Access Compliance Report

Public Rights-of-Way

(Pedestrian Signals)

Intersection ID: N/A	Main Street:	Cross Street: N/A	Location: N/A
ADA ID: E5439BF4724E	Signal Type: One Push Button-APS	Overall Compliance: No	Severity Score: BTN 1: N/A BTN 2: N/A No BTN: N/A
Codes/Mitigation Info/Possible Solution		Field Measurements/Component Compliance

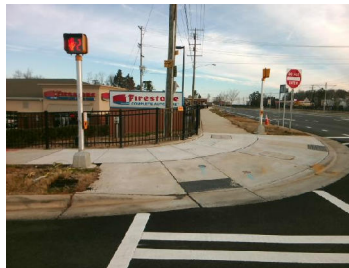
PROW/ADA: R404.2, R404.3, R404.7.2,
R209.1, MUTCD 4e.10

N/A	B 1 FWD Approach Width (in)	N/A	N/A	B 2 FWD Approach Width (in)	N/A
N/A	B 1 FWD Approach Obstruction?	Yes	N/A	B 2 FWD Approach Obstruction?	N/A
N/A	B 1 FWD Approach Obstruction Dist (in)	3.0	N/A	B 2 FWD Approach ObstructionDist (in)	N/A
N/A	B 1 PARA Approach?	Yes	N/A	B 2 PARA Approach?	N/A
N/A	B 1 PARA Approach Constrained?	Yes	N/A	B 2 PARA Approach Constrained?	N/A
Yes	B 1 PARA Approach Reach (in)	8.0	N/A	B 2 PARA Approach Reach (in)	N/A
No	B 1 PARA Approach Width (in)	48.0	N/A	B 2 PARA Approach Width (in)	N/A
N/A	B 1 PARA Approach Obstruction?	Yes	N/A	B 2 PARA Approach Obstruction?	N/A
N/A	B 1 PARA Approach Obstruction Dist (in)	3.0	N/A	B 2 PARA Approach ObstructionDist (in)	N/A
No	B 1 Clear Floor Space Slope (%)	2.3	N/A	B 2 Clear Floor Space Slope (%)	N/A
No	B 1 Clear Floor Space XSlope (%)	5.2	N/A	B 2 Clear Floor Space XSlope (%)	N/A
N/A	B 1 PAR Slope (%)	N/A	N/A	B 2 PAR Slope (%)	N/A
Yes	B 1 Height (in)	39.0	N/A	B 2 Height (in)	N/A

Possible Solutions: Remove & Replace
Replace APS Button With New APS Button.
Remove and Replace Clear Space.
